CONSIDERATION OF AND/OR ANY APPROPRIATE ACTION ON PANORAMA STREET PRELIMINARY PLAT, SITUATED IN THE PHILLIP ANDERSON SURVEY, ABSTRACT NO. 10 CITY OF PARKER, COLLIN COUNTY, TEXAS. [MACHADO]

Re: Panorama Street
 Preliminary Plat and Engineering Plan Review

As you requested, we have reviewed the Preliminary Plat & Engineering Plans for the Panorama Street Addition prepared by LJA Engineering, Inc. These documents include a new street and is therefore considered a major subdivision under section 155.025 of subdivision ordinance.

CULVERT 3

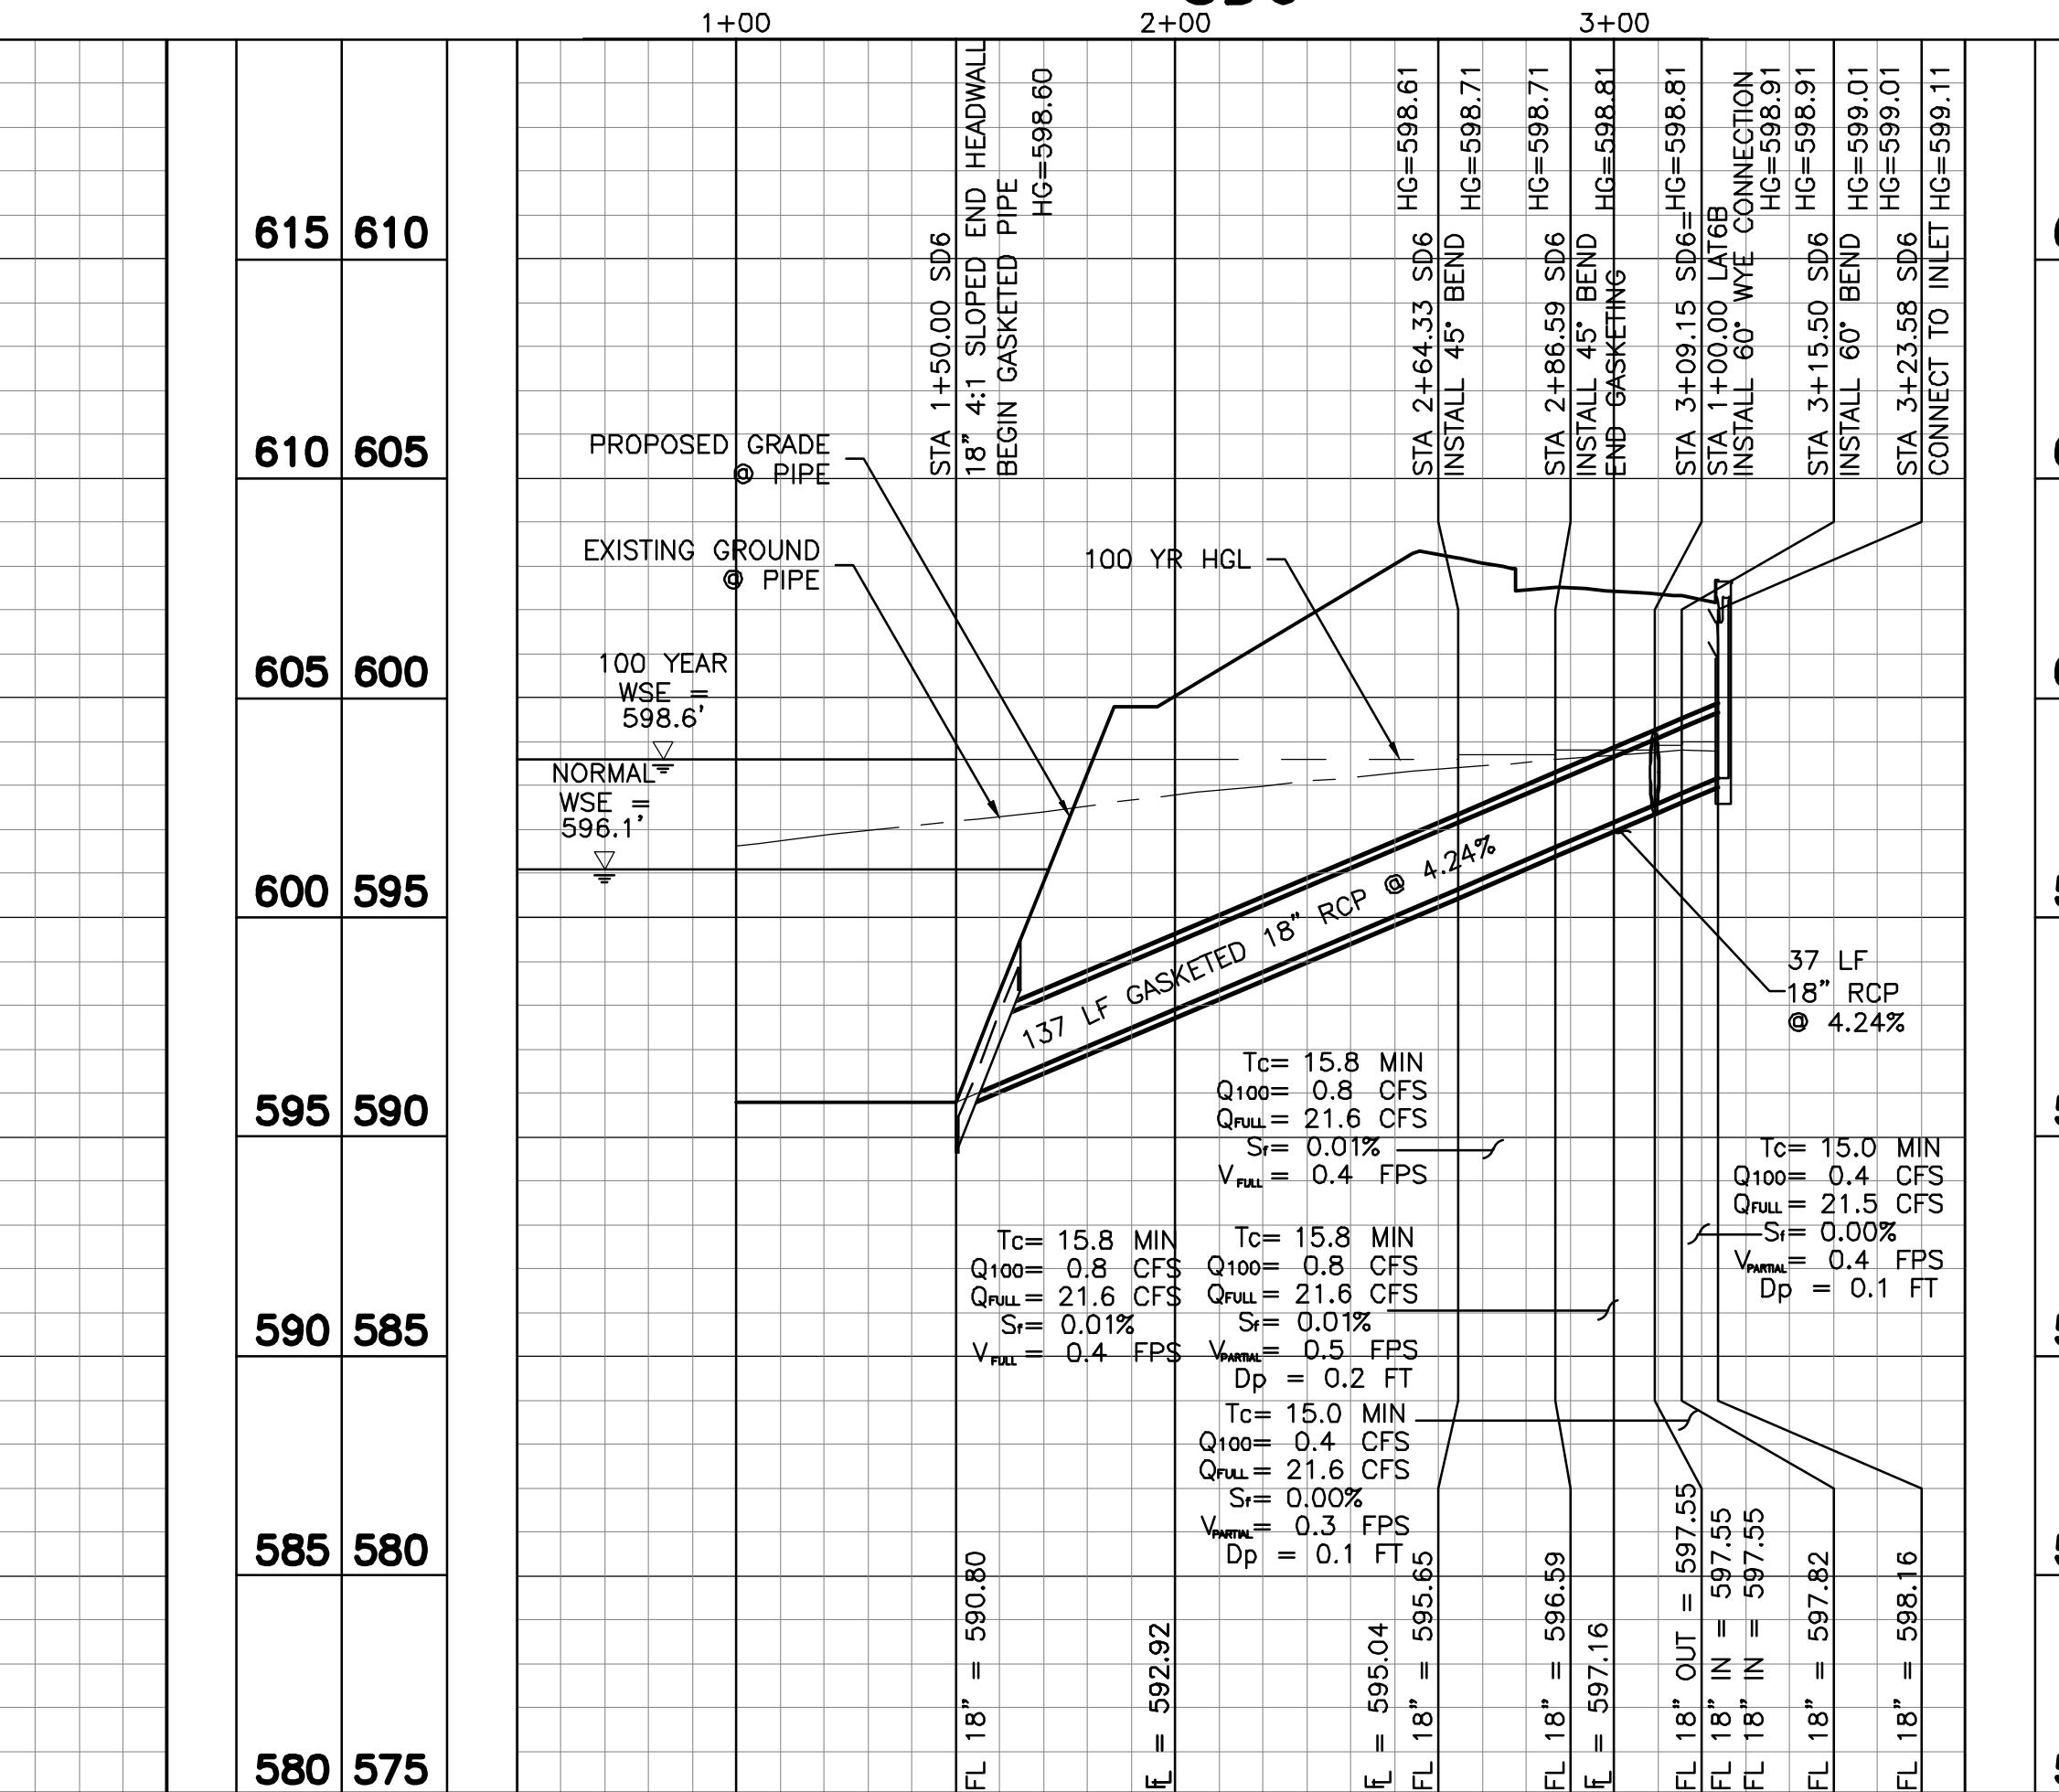
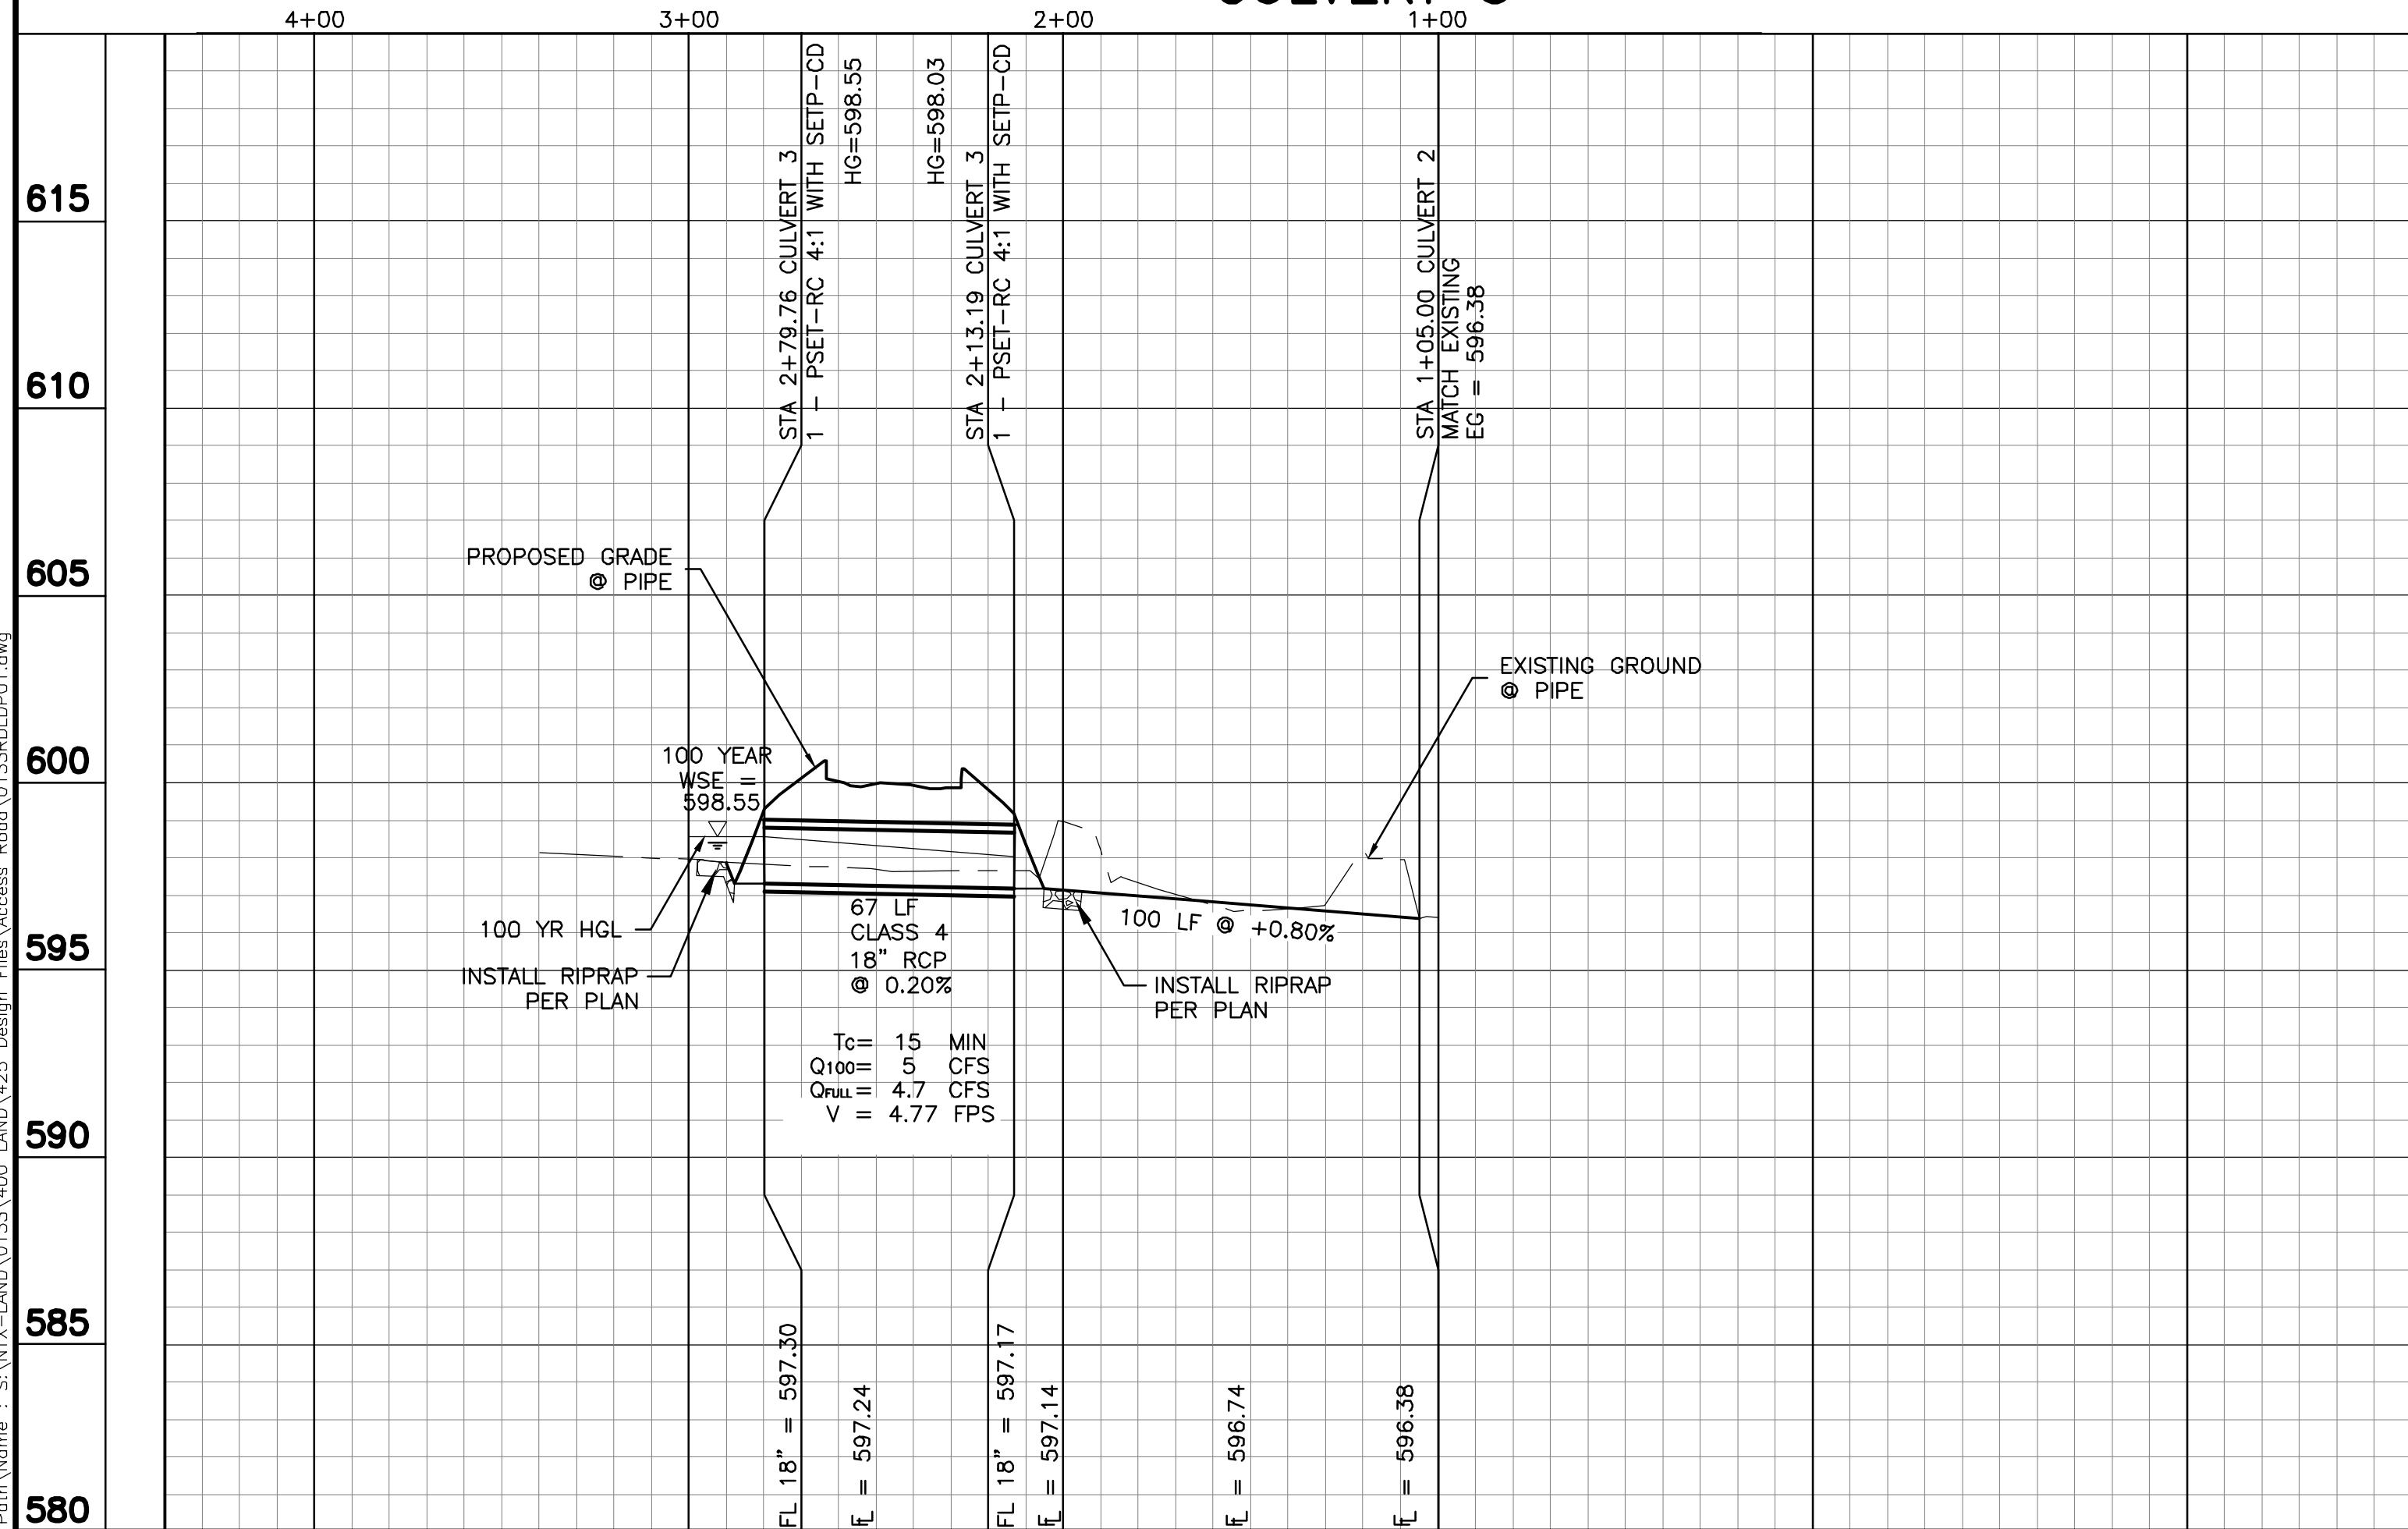
47. Sheet 20 Show depth of rip rap and geotextile fabric as foundation.
48. Sheet 20 Culvert 3 section does not correspond to what is called out in the plan view.

49. Sheet 20 Provide ASTM call out for RCP.
50. Sheet 20 Utilize radius pipe and eliminate bends.
51. Sheet 20 show footer at end of SD6.
52. Sheet 20 The call out in plan view for SD6 and Lateral 6B appear reversed to correspond with the section.
